Proposal for Supplement 9 to the 01 series of amendments to UN Regulation No. 129 (Enhanced Child Restraint Systems)

Submitted by the Working Party on Passive Safety *

Annex 15, amend to read:

Description of Conditioning for Adjusters

Figure 1
Conditioning for adjusters mounted directly on Enhanced Child Restraint Systems

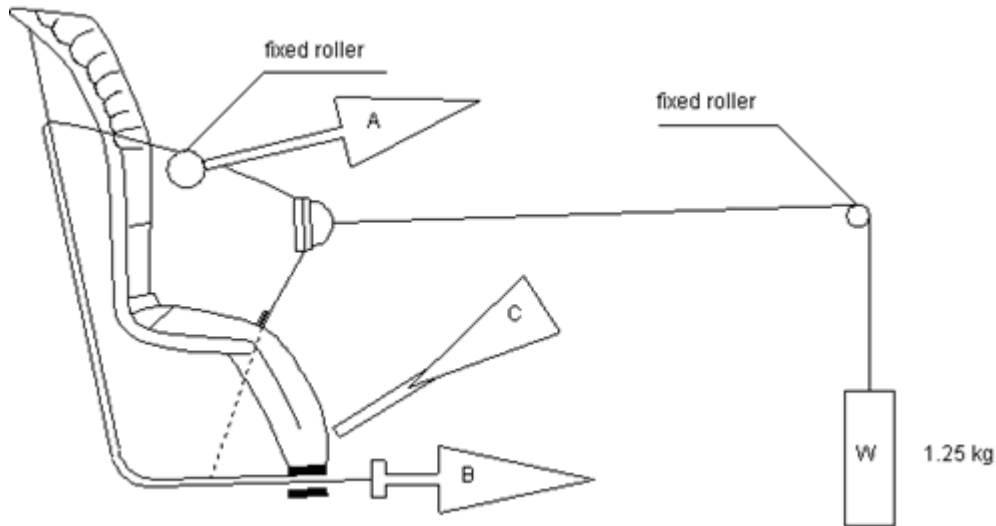
1. Conditioning for adjusters mounted directly on Enhanced Child Restraint Systems (Figure 1)
 - 1.1. Method
 - 1.1.1. With the webbing set at the reference position described in paragraph 7.2.6.1., withdraw at least 50 mm of webbing from the integral harness by pulling on the free end of the webbing.

- 1.1.2. Attach the adjusted part of the integral harness to the pulling device A.
 - 1.1.3. Activate the adjuster and pull at least 150 mm of webbing into the integral harness. This represents half of one cycle and puts pulling device A to the maximum webbing extraction position.

- 1.1.4. Connect free end of webbing to pulling device B.
 - 1.2. The procedure of the cycle is:
 - 1.2.1. Pull B at least 150 mm while A exerts no tension on the integral harness.

- 1.2.2. Activate the adjusters (C) and pull A while B exerts no tension on the free end of the webbing.
 - 1.2.3. At the end of stroke, de-activate the adjuster.

- 1.2.4. Repeat cycle as specified in paragraph 6.7.2.7. of this UN Regulation.

Figure 2
Conditioning for adjusters connected to a strap (not directly mounted on Enhanced Child Restraint Systems)

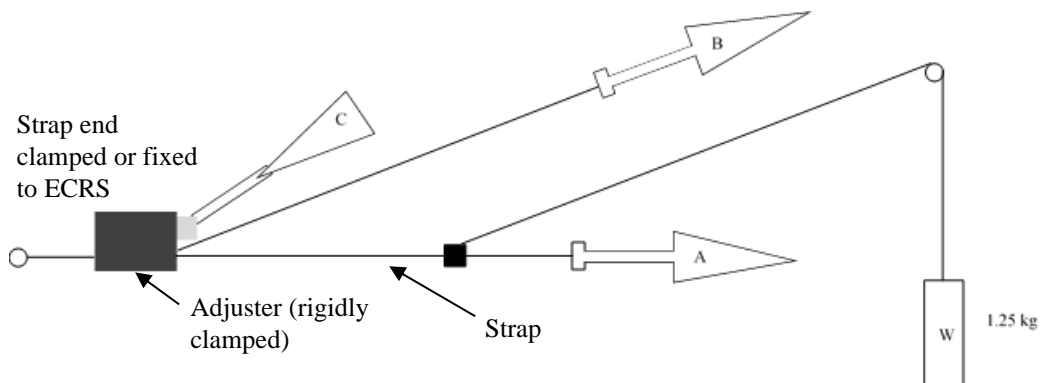
2. Conditioning for adjusters connected to a strap (not directly mounted on Enhanced Child Restraint Systems) (Figure 2)
 - 2.1. Method
 - 2.1.1. Rigidly clamp the adjuster

- 2.1.2. With the strap set at the reference position described in paragraph 7.2.6.2., withdraw at least 50 mm of strap from the adjuster by pulling on the free end of the strap.

- 2.1.3. Attach the adjuster part of the strap to the pulling device A.
 - 2.1.4. Activate the adjuster (C) and pull at least 150 mm of strap through the adjuster. This represents half of one cycle and puts pulling device A to the maximum strap extraction position.

- 2.1.5. Connect the free end of the strap to pulling device B.
 - 2.2. The cycle is:
 - 2.2.1. Pull B at least 150 mm while A does not exert tension on the strap.

- 2.2.2. Activate the adjuster (C) and pull A while B does not exert tension on the free end of the strap.
 - 2.2.3. At the end of the stroke, de-activate the adjuster.

- 2.2.4. Repeat the cycle as specified in paragraph 6.7.2.7. of this Regulation."
